ULNRC-2513

DOCKET NUMBER
CALLAWAY PLANT
CORE OPERATING LIMITS

Attached, please find revisions to Figure 2 and Section 2.4.1 of the Callaway Cycle 5 COLR. Figure 2 provides a graph of the Rod Bank Insertion Limits versus Rated Thermal Power. This revised figure may be directly substituted for the current version in the Callaway Cycle 5 COLR and represents Revision 2 of this document. Section 2.4.1 specifies the Axial Flux Difference target bands applicable for burnup levels achieved from the date of this letter through the end of Cycle 5. The revised page 7 of 15 (attached) may be directly substituted for the current page 7 of 15 in the Callaway Cycle 5 COLR and represents Revision 3 of this document.

FIGURE 2

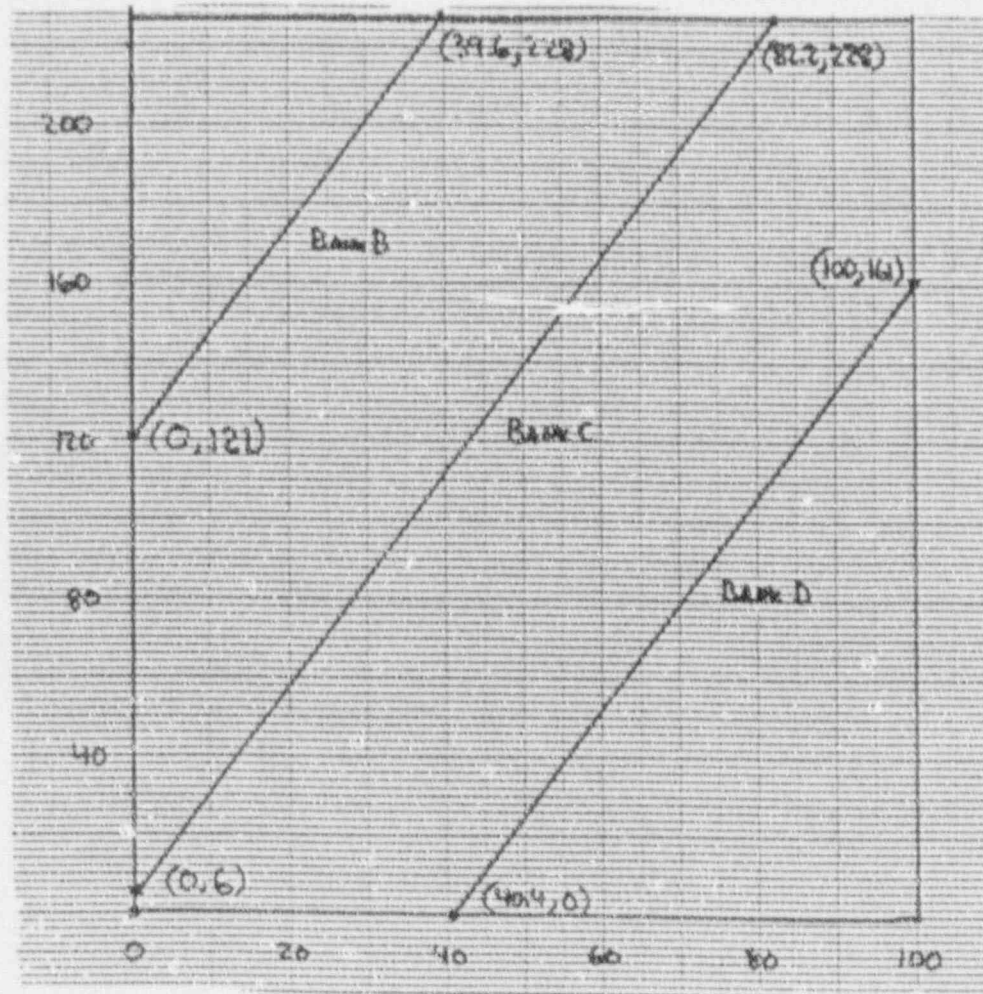
These revisions do not result in any change to any RSAC parameter nor do they impact either the LOCA or non-LOCA transient analysis previously performed for the remainder of Cycle 5. Should you have any questions concerning this information, please contact us.
